CITY OF PUNTA GORDA ADA TRANSITION PLAN FINAL REPORT

Laishley Park

October 4, 2017

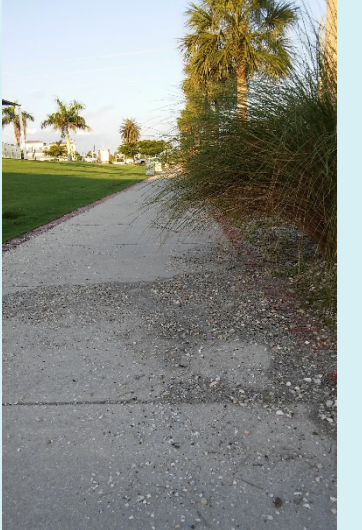
Map Item	Description & Recommendation	Photo(s)
<p>C1</p>	<p>3.3% cross slope – Resurface so the cross slope is no greater than 2%</p>	
<p>C2</p>	<p>3.5% cross slope – Resurface so the cross slope is no greater than 2%</p>
